Access Compliance Report

Public Rights-of-Way

(Curb Ramps)

Intersection ID: 25839	Main Street: CORPORATE_CENTER_DR	Cross Street: JOHNSTON_RD	Location: NW
ADA ID: C026C9A030B1	Ramp Type: PerpDiag	Initial Pass/Fail: Fail	Overall Compliance: No
Codes/Mitigation Info/Possible Solution			Severity Score: 25
			Field Measurements/Component Compliance

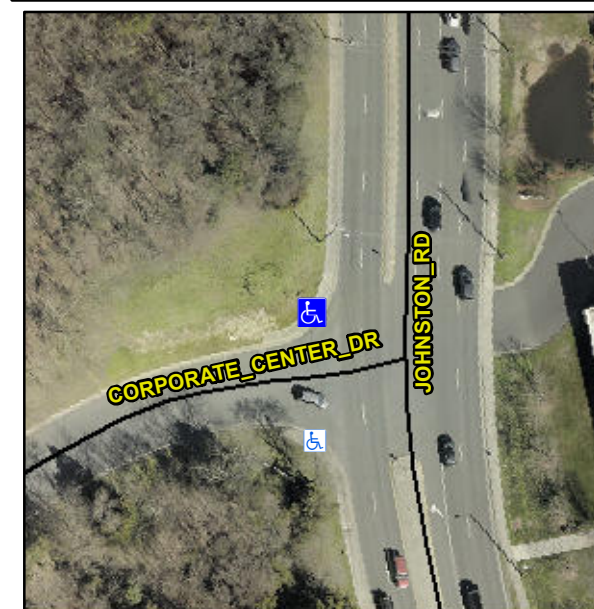
Not Found, R304.2.2, R304.5.3

Compliance	Description	Data	Compliance	Description	Data
N/A	Ramp Length (in)	56.0	No	Ramp Slope (%)	8.4
Yes	Ramp Width (in)	48.0	No	Ramp XSlope (%)	5.7
N/A	Flare Type LT	N/A	N/A	Flare Type RT	N/A
N/A	Flare Slope LT (%)	N/A	N/A	Flare Slope RT (%)	N/A
N/A	Flare Traversable LT?	N/A	N/A	Flare Traversable RT?	N/A
N/A	Landing Length (in)	N/A	N/A	DWS Provided?	N/A
N/A	Landing Width (in)	N/A	N/A	DWS Contrast?	N/A
N/A	Landing Slope (%)	N/A	N/A	DWS Length (in)	N/A
N/A	Landing X Slope (%)	N/A	N/A	DWS Full Width?	N/A
N/A	Landing Curb? (Y/N)	N/A	N/A	DWS Offset (in)	N/A
N/A	Shared Landing?	N/A			
N/A	Gutter Ponding?	N/A	N/A	Gutter Slope (%)	N/A
N/A	Gutter Lip Ht (in)	N/A	N/A	Gutter X Slope (%)	N/A
N/A	Painted X Walk1?	No	N/A	Painted X Walk2?	No
	X Walk 1 Direction	To S		X Walk 2 Direction	To E
N/A	X Walk 1 Width (in)	N/A	N/A	X Walk 2 Width (in)	N/A
	X Walk 1 Slope (%)	1.1		X Walk 2 Slope (%)	5.8
	X Walk 1 X Slope (%)	5.0		X Walk 2 X Slope (%)	4.4

Remove & Replace Curb Ramp With Two New Directional Ramps or Equivalent.
